Rocky Flats Environmental Technology Site: Actinide Migration Evaluation

Meetings: June 7-9, 2004

Advisory Group: Greg Choppin, David Clark, David Janecky, Leonard Lane

Summary and Recommendations for Path Forward

Figure 1a. 903 pad lip remediation site, looking southwest from road.

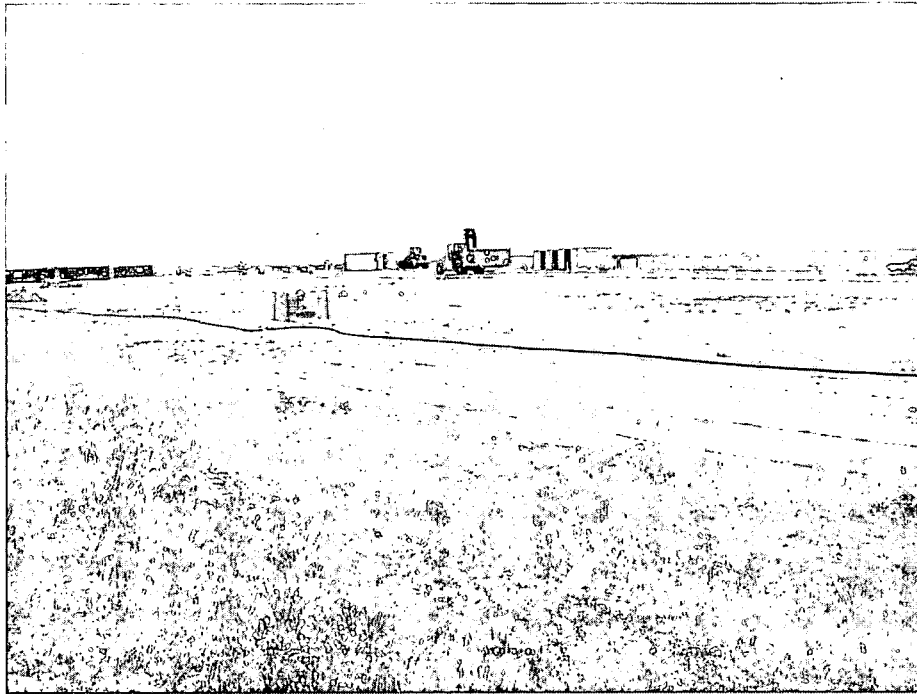
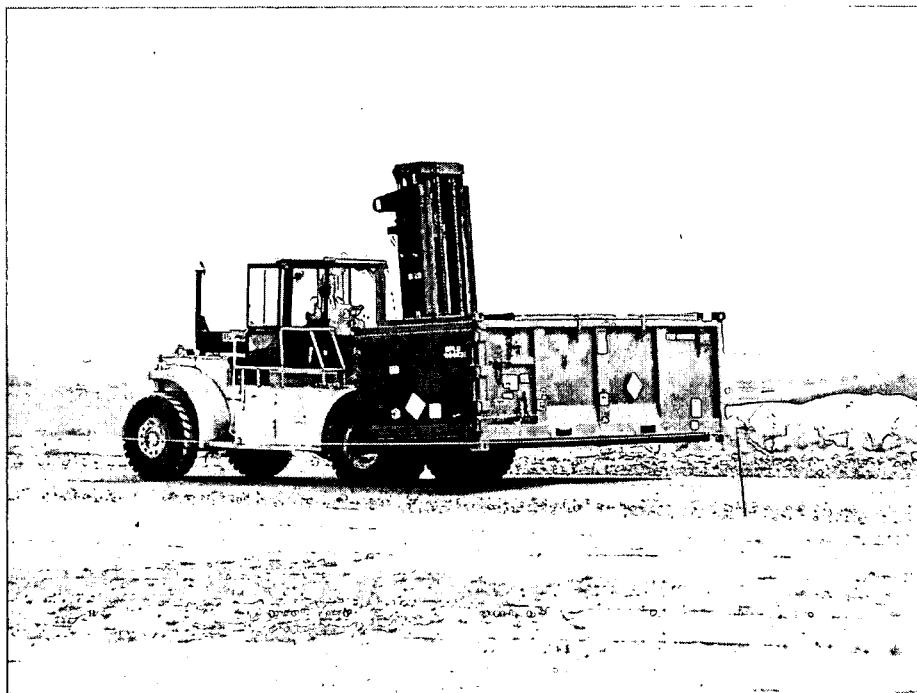
For example, we observed and discussed the operations and soil erosion control measures being taken in the 903 Pad Lip Area. An example of this area is illustrated in Figure 1. Notice the staked and delineated improved road (uncontaminated base coarse) controlling the driving area of the vehicles, the erosion control mats, and emerging vegetation. Taken together, these and other, features are key operational and remedial erosion control measures. Our discussions at this site emphasized the improved remediation actions, which include erosion control measures at the contaminant source area and the fact that the remedial erosion control actions (e.g., the erosion control matting) are emplaced as soon as possible after the disturbance to the soil surface. These "source area controls" and "immediate emplacement" actions are critical to effective erosion (and thus actinide transport control).

As an example of a good management practice, the AME advisors were impressed with the outstanding progress on the remediation of the 903 Pad and Lip area. This project employed a combination of tents, comprehensive erosion control measures, and general environmental protection during cleanup activities. An outstanding IM/IRA document provided a comprehensive plan, and scientific basis for selection of state-of-the-art engineering erosion control that was spatially close to the source and temporally close to the disturbance. The monitoring stations have shown little change in actinide migration as a result of

Figure 2. Tire ruts, exposed soil, spoil pile and staged storage containers on remediated area in front (SE) of Solar Ponds area.

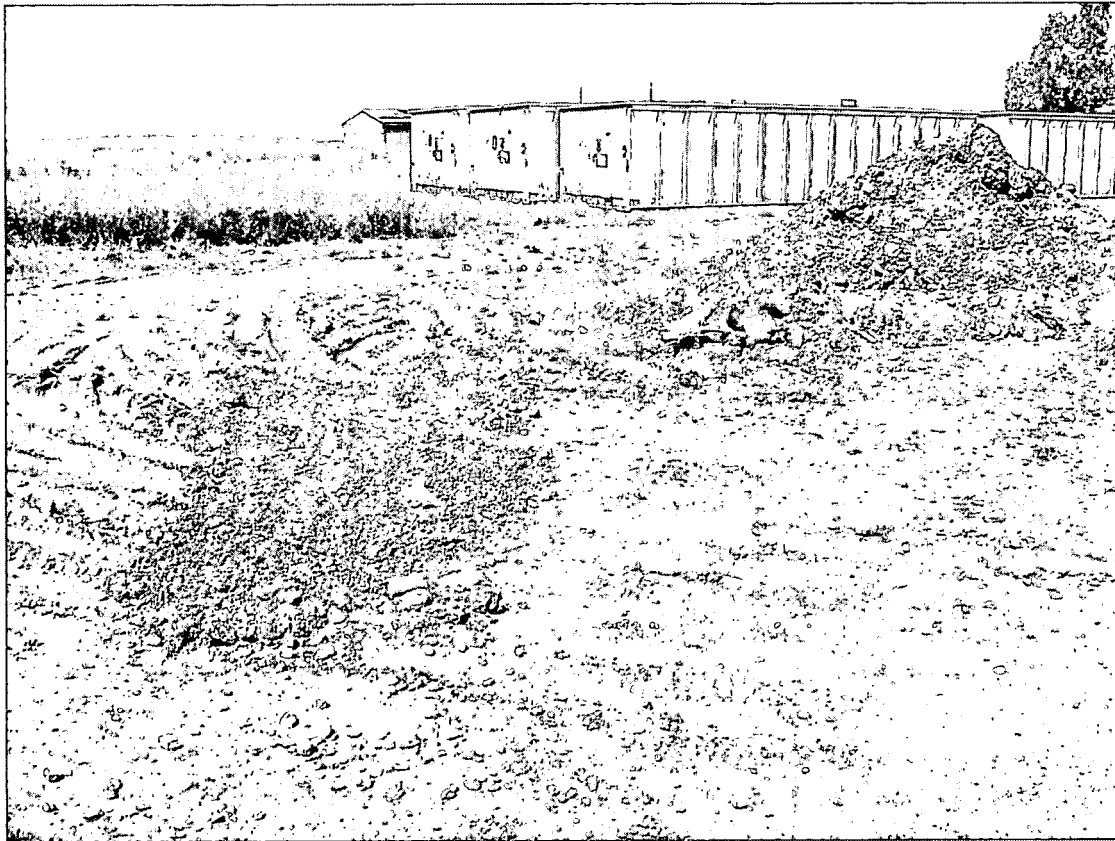
In contrast with the improved erosion control measures seen at the 903 Pad Lip Area, the situation at the Solar Ponds area was quite different (Figure 2). Notice the storage bins and evidence of vehicle traffic, which has destroyed the heavy vegetation cover in the Solar Ponds area. These practices leave large areas of bare, exposed soil subject to high soil erosion rates from wind and water. Also, notice the soil spoil pile of unknown origin and of unknown contaminant concentration. This too presents an exposed sediment and potential contaminant source area. The conditions illustrated in Figure 2 were widespread in the areas observed; there are significant areas of bare soil, disturbed soil, soil spoil piles, and soil from OPWL line excavations. The spoil piles from the OPWL we investigated had an RWP warning sign indicating possible actinide contamination. All of these sites are subject to significant erosion and potential for contamination mobility.

In contrast, it appears that similar comprehensive plans and practices could or should be employed more uniformly across the Site. During a Site tour, we observed locations with unprotected bare soil and soil piles – some with known or suspected soil concentrations of Pu. This situation represents a significant vulnerability with the potential to cause exceedence of the 0.15 pCi/L surface water standard through wind or water erosion (see figures 1 and 2 above).

These observations lead us to respectfully suggest that D&D and ER activities need to be better coordinated at the highest levels by Site management. This is necessary to make sure that the interfaces between D&D, Remediation and Environmental protection do not lead to exposure of unprotected contaminated soils at levels that that could result in exceeding one of these standards. Every employee working on Site needs to understand how their individual actions can impact the ability of the Site to meet the compliance standards. This could be accomplished by a slight modification of the ISM concept to an Integrated Safety and Environmental Management (ISEM) concept. As part of defining work, and analyzing hazards, workers should also analyze the impacts of their actions on erosion and sediment transport. All workers should be aware of the need to minimize loose piles of dirt, driving over (re-)vegetated areas, etc.
